#### Other Regulations – Regulation No. 6 (Direction indicators)

## **Proposal for Supplement 27 to the 01 series of amendments to Regulation No. 6 (Direction indicators)**

### **Submitted by the expert from the International Automotive Lighting and Light Signalling Expert Group (GTB)\***

*Category 1b*: For use at a distance less than or equal to 20 mm from the dipped-beam headlamp and/or the front fog lamp.

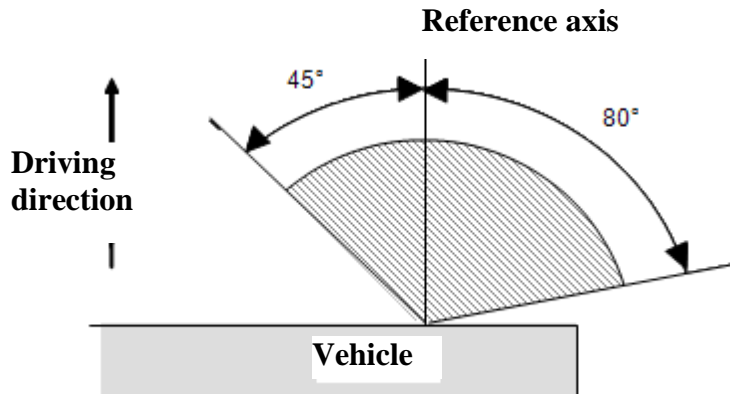
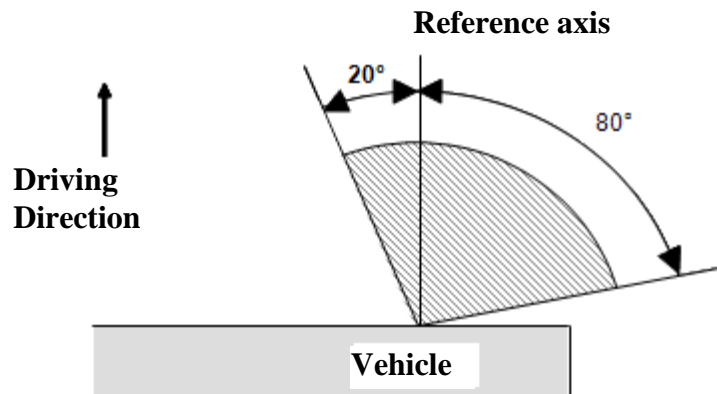
*Annex 1*, amend to read (note: the diagrams are not changed):

On and above the H plane  
for all lamps:  
Under the H plane for  
lamps intended for M<sub>2</sub>, M<sub>3</sub>,  
N<sub>2</sub> or N<sub>3</sub> category of  
vehicles

Under the H plane for lamps  
intended to be installed with  
this plane at a mounting  
height less than 750 mm  
above ground
